STATKRAFT / ELECNOR / ANDRITZ
Feedback to Eirgrid SCU Grid Code Modification
(particularly related to clause SCU 1.4.6.3)

Figure 1 – Possible default interpretation for SCUs that can provide a greater reactive power capability than the minimum Grid Code requirement

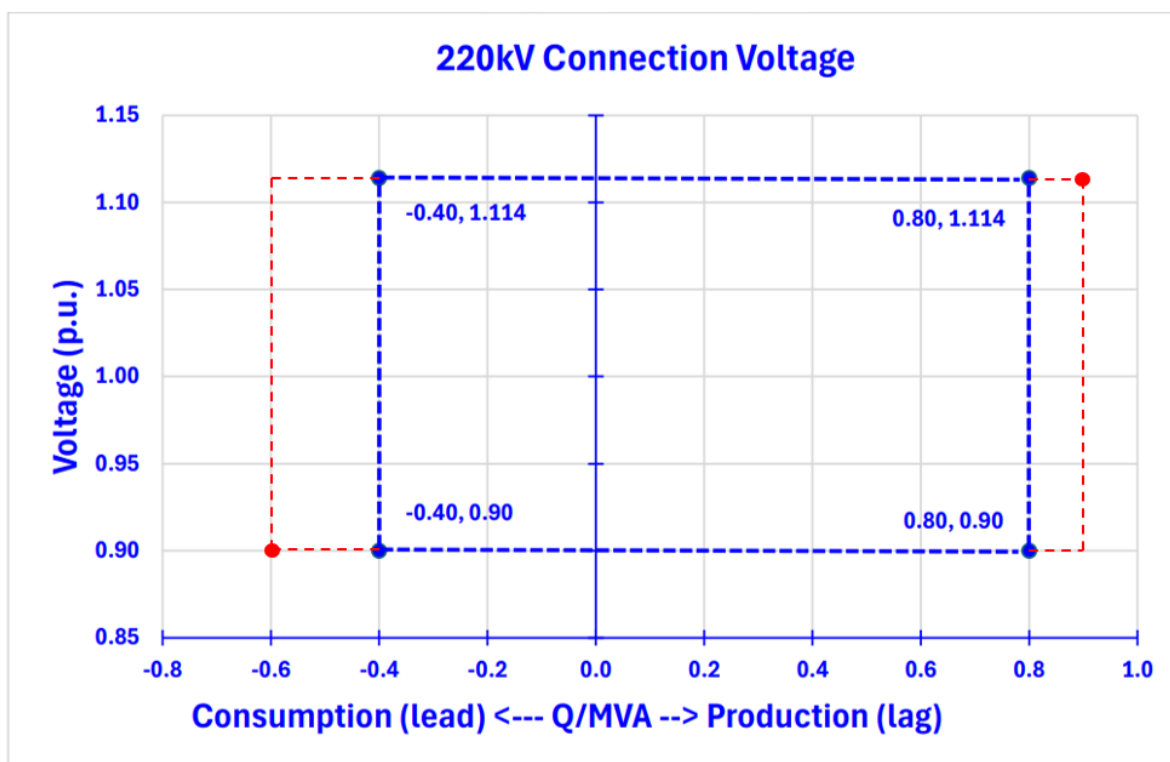
For example, an SCU contracted under the LCIS Arrangements is incentivized to provide reactive power capability ≥ 0.9 p.u (lagging) and ≤ -0.6 p.u. (leading) in order to achieve the maximum possible Reactive Power Product Scalar. In the absence of any explicit clarification, a likely default interpretation of the Grid Code for such an SCU could be that the reactive power capability at ≥ 0.9 p.u (lagging) and ≤ -0.6 p.u. (leading) must be provided along the entire voltage range (i.e. from 0.9 p.u. to 1.114 p.u. for a 220kV connection). This is represented by an extension (red dashed line) of the proposed rectangular grid code requirement as shown below.

- The operational points shown in red at the top right (max voltage, max var) and bottom left (min voltage, min var) of the extended rectangular box in Figure 1 are challenging for thermal and stable operation of a synchronous condenser machine.
For example, to meet the top right corner in the over-excited range, an SCU would need to operate with an overvoltage (e.g. >1.05 p.u.) on the SCU machine terminals. Similarly, to meet the bottom left operating point in the under-excited range, the SCU would need to regulate to a higher than nominal target voltage on the SCU machine terminals (e.g. >1 p.u.). These are not ideal operating conditions from either an SCU or System Operator perspective.

Therefore, the only option to comply with the requirement at these extremes indicated in Figure 1 would be to either oversize the synchronous machine and/or oversize the power transformer neither of which is economical to do. It is also important in this context to recognise the difference that exists between units that produce Active Power and units that do not produce Active Power (e.g. SCUs).

Figure 7 : Exemplary specified operation range of a synchronous condenser plant at PCC – rectangular shape (blue) vs. different extent of clipped corners (green).

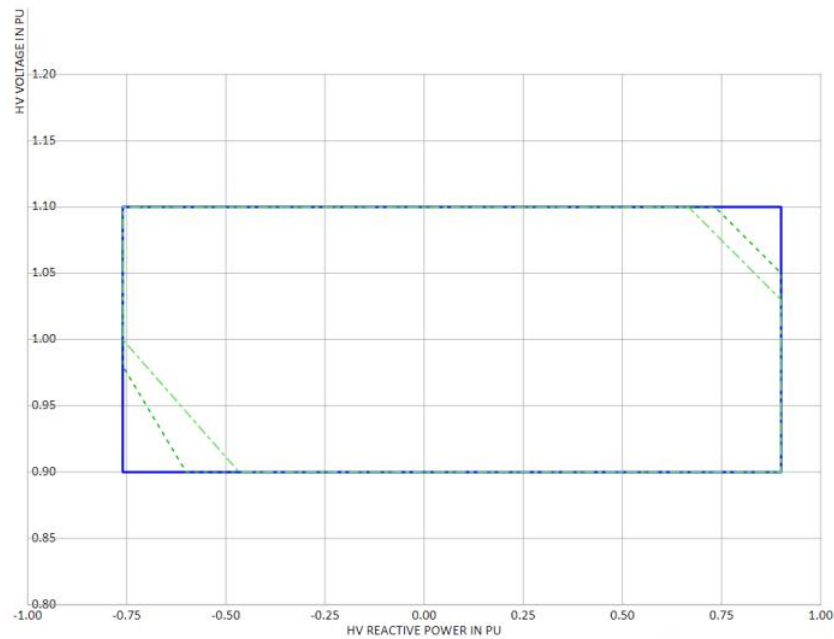
A report on the *Design Aspects of Synchronous Condensers* [1] submitted by ANDRITZ to CIGRE in the 2024 Paris Session makes this very case that it is neither the optimal technical or economic solution to design and operate a synchronous condenser at these extreme points **[emphasis added]**:

"As those areas are determining the synchronous condenser design, restricting operation in those areas or even clipping these two extreme corners **will yield a more economic condenser solution**. Furthermore, it was recognized that the **lower left and upper right operating corners are not good engineering practice in terms of voltage control** ([8])."

Figure 9 - (Solution A)

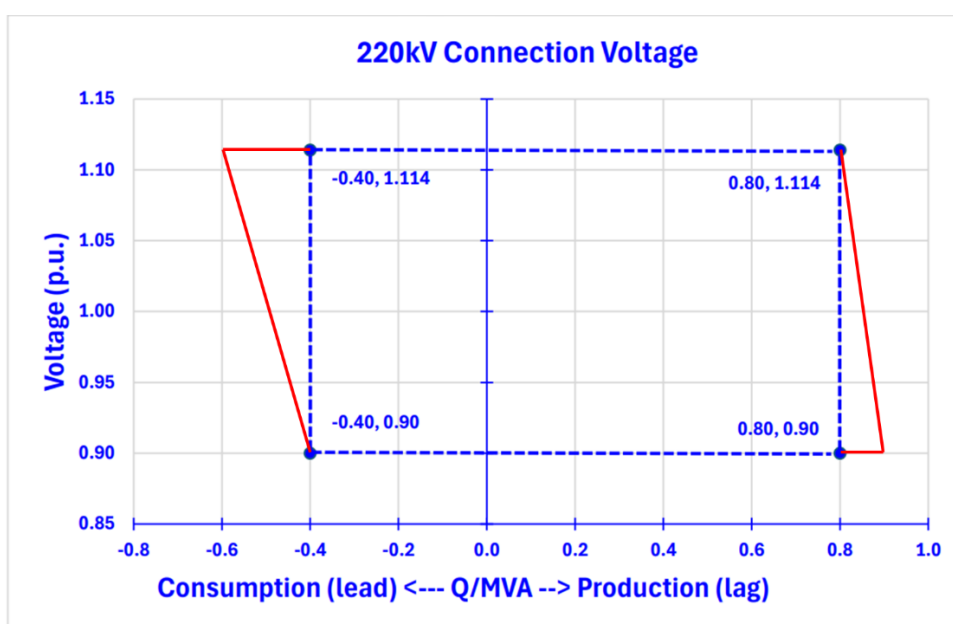
In order to avoid any ambiguity in the Grid Code, we propose that the following text (shown in the black box below) is added to clause SCU1.4.6.3. This point is further represented by the red lines in Figure 9 below (which are shown for illustrative purposes only and not intended for inclusion in the Grid Code).

SCU1.4.6.3 Synchronous Condenser Units connecting to the Transmission System shall comply with the following Reactive Power requirements at the Connection Point. The Synchronous Condenser Unit shall be capable of moving to any operating point within its U-Q/MVA profile in appropriate timescale to target values. The appropriate timescale shall be identified during the TSO's Connection Offer process.

Where Synchronous Condenser Units can provide reactive power capability beyond the envelopes shown, the additional capability may not have to be provided across the full voltage range and the slope for the additional capability shall be agreed between the TSO and the Synchronous Condenser Operator.

Figure 10 - (Solution B)

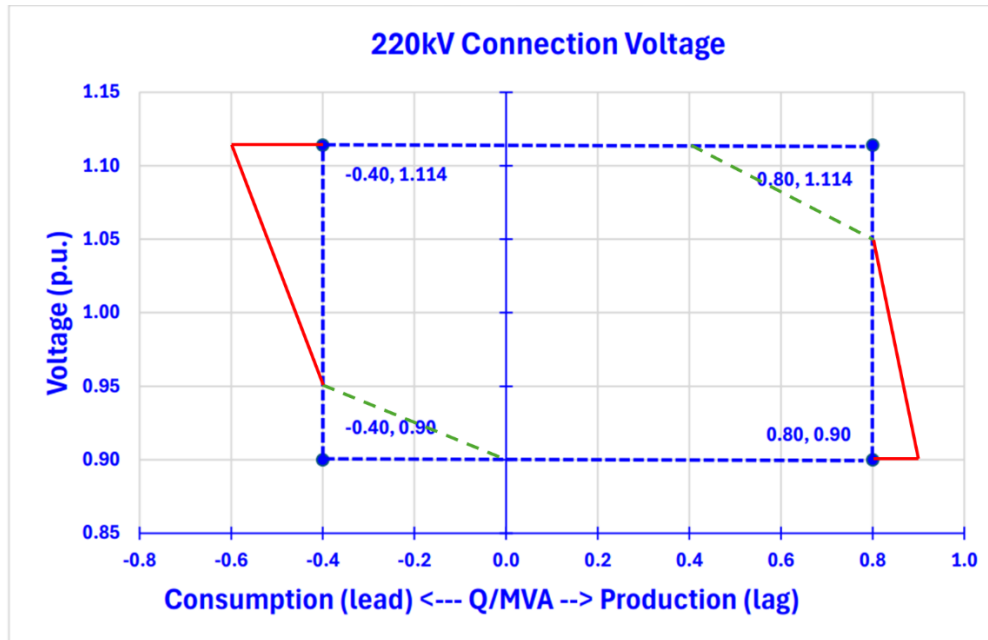
Furthermore, for the reasons outlined in Section 2 and Section 3 and the limited benefit to the System Operator outlined in our original feedback referenced in Section 1, we believe there is a strong case that the region within the proposed rectangular reactive power requirement (i.e. ≤ 0.8 p.u and ≥ -0.4 p.u) should also be clipped as shown in Figure 10 below. This is represented by the green dashed lines which is proposed to be included in the Grid Code if Solution B is accepted. The continuation of the lines outside the minimum Grid Code requirement equivalent are shown again in red for illustrative purposes only and not intended for inclusion in the Grid Code, as this would be already addressed by inclusion of the text proposed in Solution A.
